# PCB Cost Reduction and EMC – A Cautionary Tale

The subject is a 4 layer design that originally passed EMC testing which was then reduced to a 2 layer design and subsequently failed. We'll go into the main findings of an initial EMC design review I did on the 4 layer design, then go into the changes needed to get the 2 layer board to pass.

## **Original 4 Layer PCB**

## 4 to 2 Layer Cost Reduction

FLAME BOSS ORIGINAL 4 LAYER PCB STACK

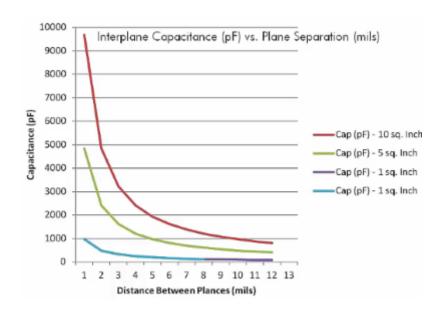
A good place to start with an EMC design review is the foundation of your design – the PCB layer stack. So this is the first place I looked.

In this design, the Flame Boss used the typical PCB stack recommended for 4 layer boards which is routing/components on the top and bottom layers, with the middle two layers reserved for power and ground flood.

As you can see from the thickness dimensions in the table above, the routing layers were tightly coupled together, with a thick core (47 mils) between the GND and VCC layers.

From an EMC perspective, ideally the PWR/GND layers are tightly coupled which increases interplane capacitance. That increases the plane's ability to provide current at very high frequencies to satisfy any IC's demand.

But on a 4 layer board, it's usually preferable to sacrifice the increased interplane capacitance to minimize return path loop areas and make controlled impedance track widths thinner instead.

So, the stack looks good.

## List of EMC/EMI Improvement Recommendations

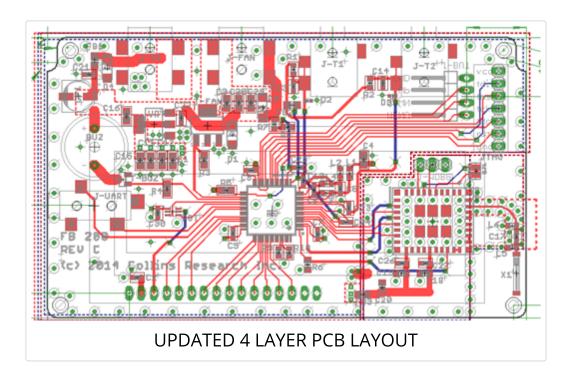
Although the design possibly would have passed emissions testing without any changes, the EMC design review was an opportunity to improve the electromagnetic performance and de-risk the certification process.

The main items I recommended changing in the original 4 layer design were:

- Improve decoupling in several specific areas
- Optimize decoupling by improving decoupling cap orientation and via spacing
- Increase track width of several power supply rails to decrease PDN impedance (and reduce power supply noise)

- Add ferrites for local analog supply rails and RF supply rail
- Re-routed some parts of the circuit board to minimize tracks on the back of the PCB
- Pin swap LCD interface on MCU to make signals flow to connector without jumping layers

- Insert series resistors on several serial interface signals to add some slew rate limiting and termination. Or at least place 0 ohm placeholders to use as get out of jail free cards

- Insert placeholders for R-C low pass filters on each signal heading off to LCD
- Reduce drive strength on all driven signals from MCU where bandwidth allows

- Add GND stitching vias across the board every 10mm-20mm to reduce possibility of plane resonance happening
- Use shielded cable for PWM fan
- Recommend adding ESD protection diodes to temperature probe signals as close to connectors as possible

- Add low pass filters (simple R-C) with low bandwidth (e.g. 500 Hz) to analog inputs. This protects against radiated fields coupled to the cabling from radiated immunity EMC testing (61000-4-3).

Based on the initial review, Roger modified the PCB to improve the EMC/EMI performance prior to the final test schedule.

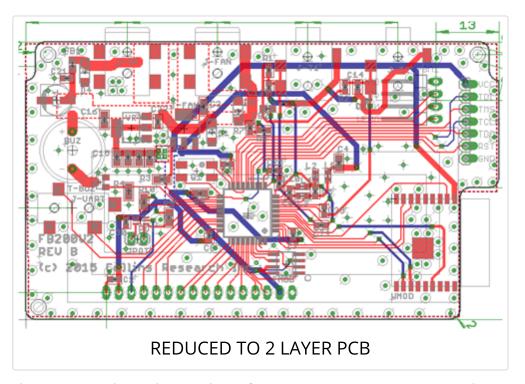
What we can see is that since the internal layers have

disappeared, we lose a lot of routing options. As a result, you can see a lot more tracks routed on the bottom side of the PCB, including power and data tracks. This has the significant downside of turning the ground plane (and other return paths) into swiss cheese.

Things suddenly looked not quite so nice and from what I saw of the new design I immediately suspected that there were probably some return path issues that had been introduced.

### **Analyzing the Radiated Emissions Plot**

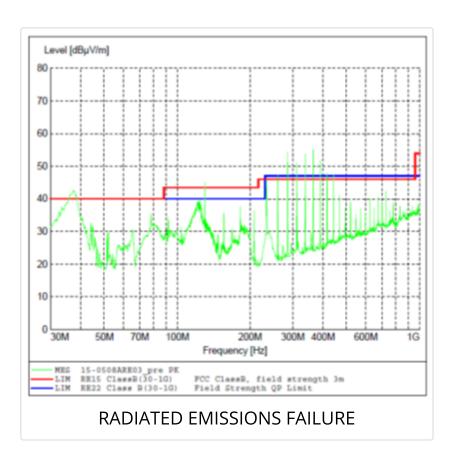
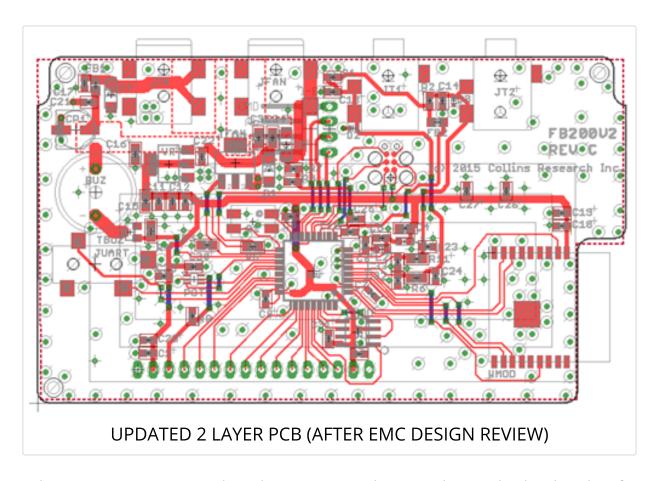
By the profile of the emissions (frequency, bandwidth, power etc.) it looks like we have 2 or more separate issues to deal with.

#### Bump at 30-40 MHz

With relatively low frequency, broadband 'bumps' like the one you can see between 30-40 MHz, I usually suspect things like motor driver circuits or switching power supply circuitry.

We do have a PWM circuit on board to drive the fan motor, so I would suspect something could be wrong in the drive path here.

#### Broadband noise around 120 MHz

Again I'd be looking for anything electro-mechanical first. I noticed there is also a piezo-electric buzzer in the design, which in theory should have been 'on' for test purposes. Test labs always want to measure worst case scenario which means every area of your circuit should be operational.

Again, this may not be the issue, but the broadband nature of the emission made me look carefully at the drive paths for both the motor driver and buzzer circuits. With a near field probe set or small GTEM, you could figure it out pretty quickly, but I didn't have a board in hand to confirm.

#### Narrowband emissions at 100-200 MHz

Narrowband 'spikes' like these in this frequency range are typically harmonics of clock frequencies present somewhere on board the product. It could be a main processor clock, or internal core clock (often PLL'd up to a multiple of an external crystal frequency) or a bus clock (e.g. parallel/serial databus switching frequency).

In this case the spikes are spaced at exactly the frequency of the processor clock, so we suspect that it's noise from the processor that's being radiated through some mechanism.

#### **Emissions at 200-500 MHz**

The narrow spikes about 26 MHz apart at the higher frequencies also appear to be harmonics from a clock in the unit. This is very likely related to the same processor emissions issue, so I'm quietly confident that if we solve that, these harmonics will also decrease in amplitude.

Overall you can see that the device failed at several frequencies by anywhere between 1 and 7 dB.

## Result

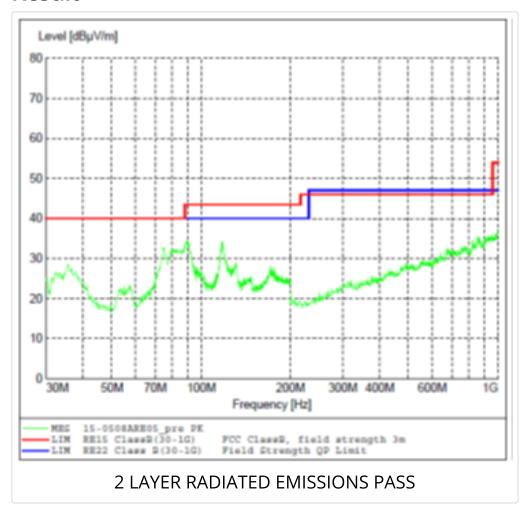
What you can notice is that there are way less tracks on the back side of the PCB now. The idea behind this is:

- To minimize ground plane inductance by making the ground plane as big and contiguous as possible
- To minimize the creation of unintentional current loops in the return paths

Here are some of the changes I implemented:

- 1. Added extra decoupling at power supply input
- 2. Re-routed tracks around the RF module to avoid tracks on ground layer as much as possible

- 3. Added decoupling caps at several places along the main power track to maintain low impedance PDN and provide shorter path for noise currents to return to their source

- 4. Moved the big JTAG connector in the upper right hand corner of the PCB closer to MCU to minimize track length and provide more routing space on top layer

- 5. Merged analog/digital grounds and analog/digital power supplies. In this case, separating analog and digital supplies/grounds actually made the performance worse because the extra tracks cause several return path issues

- 6. Prioritized power tracks on the top layer. One of the highest risk areas was the power track routed on the bottom side right across the LCD data signals.

- 7. Moved some components to make the tracks flow more smoothly on the top layer
- 8. Standardized several decoupling capacitor values to 100 nF to avoid creating resonances in the PDN

- 9. Added decoupling next to LCD power pins
- 10. Some other minor tweaks...

Most of the work was moving components and re-routing to avoid tracks on the reverse side of the PCB as much as possible so that the ground plane could remain contiguous and return paths are uninterrupted.

I also improved decoupling in several areas and re-routed the main VCC supply to try to reduce the power supply inductance/impedance.

Although not shown here, I also recommended adding series resistors (0 ohm placeholders or 10-30 ohm-ish) next to the MCU for all drive signals destined to go off board to the LCD. This is like providing yourself with a get out of jail free card if the LCD interface should ever prove to be a problem from a radiated emissions perspective.

Another good contingency is to add X2Y capacitors on the fan motor casing itself and on the PCB next to the motor connector. If there's any possibility that the fan is causing any component of the noise (e.g. the 30-40 MHz bump or the 120 MHz bump) these X2Y caps can be extremely effective at decoupling the noise currents.

After the board was re-manufactured with these changes (and some more that Roger used to finish off the design), the emissions were greatly reduced as you can see above.

The broadband bumps at 30-50 MHz and  $\sim$ 120 MHz were reduced by 5-10 dB.

And the narrowband noise associated with the MCU have disappeared below the noise floor of the analyzer.
